Rezoning Transportation Analysis

Petition Number: 2017-149

Date	Description
10-23-17	First Review
11-15-17	Second Review

Figure 13a: South Boulevard Segment 1 Proposed Section (Long term)

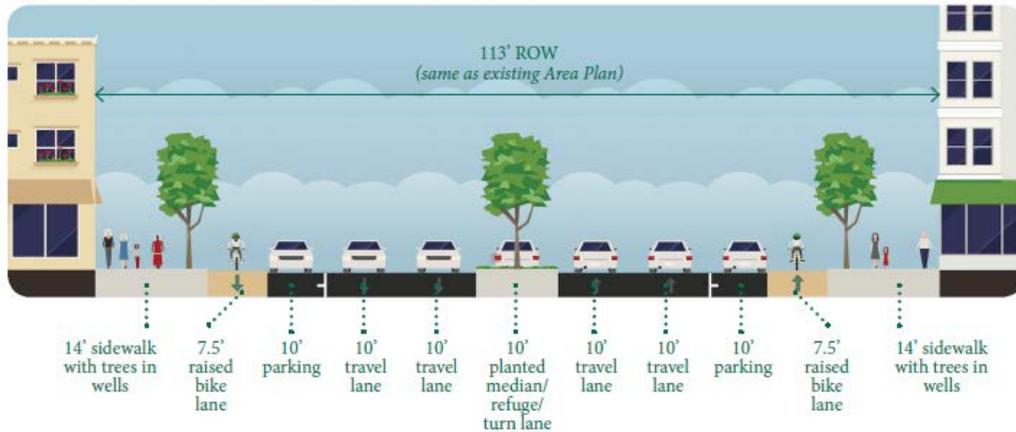
- a. Kingston Av — the existing curblines are in the correct location per the area plan
 - b. South Blvd — 42.5' from centerline to accommodate the long-term cross section envisioned by the South Blvd-South Tryon Corridor Study. CDOT recognizes that the proposed reuse of an existing building overlaps with this curblines and will work with the petitioner to determine how to address this in the plan and notes for this project and future development when the existing building may be demolished.

5. CDOT recognizes that the future cross section will not be implemented across the entire site frontage. However, the petitioner should revise the site plan to show the future curblines as described in item 1 and future right of way across the South Blvd frontage as 59' from existing centerline to accommodate the long-term cross section envisioned by the South Blvd-South Tryon Corridor Study. CDOT and the petitioner will determine how the existing, near-term, and/or long-term curblines, streetscape, and right of way dedications will be accommodated for the current project across the outdoor space frontage and future development when the existing building may be demolished.
